APPLICATION NO.	FILING DATE	FIRST NAMED INVENTOR	ATTORNEY DOCKET NO.	CONFIRMATION NO.
10/659,615	09/10/2003	Gerald Joseph McCarty	6112.102US	5570
7590 12/01/2004				
Lawrence R. Oremland, P.C. Suite C-214 5055 East Broadway Blvd. Tucson, AZ 85711		EXAMINER GREEN, CHRISTY MARIE		
		ART UNIT 3635 PAPER NUMBER

# Office Action Summary

This is a first office action for serial number 10/659615, entitled Dome kit, structure and method, filed on September 10, 2003.

FIG. 2

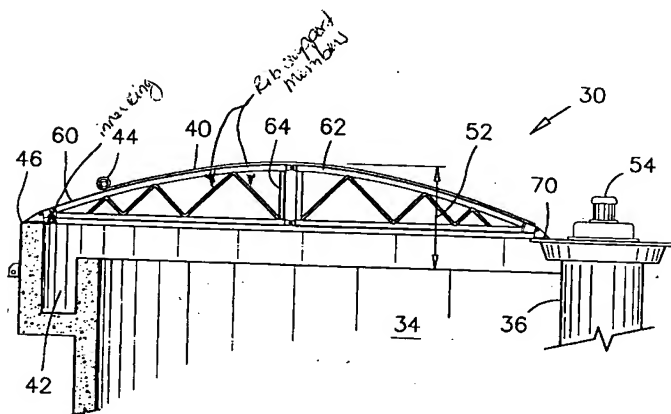
(attached figures 2 and 3) comprise angle members fixed to portions of the lower ring sections (via 60 and 62); a method of forming a dome shaped structural system, comprising the steps of a. providing a compression ring (64), b. providing a lower ring (32) with a larger but similar shape to the compression ring (64 – figure 9), c. providing a plurality of ribs (66, 60), d. positioning the compression ring (64) in relation to the lower ring (32 – column 5, lines 44-46), e. connecting the ribs (66, 60) with the lower ring (32) and the compression ring (64) to form a dome shaped structural system (figure 10).
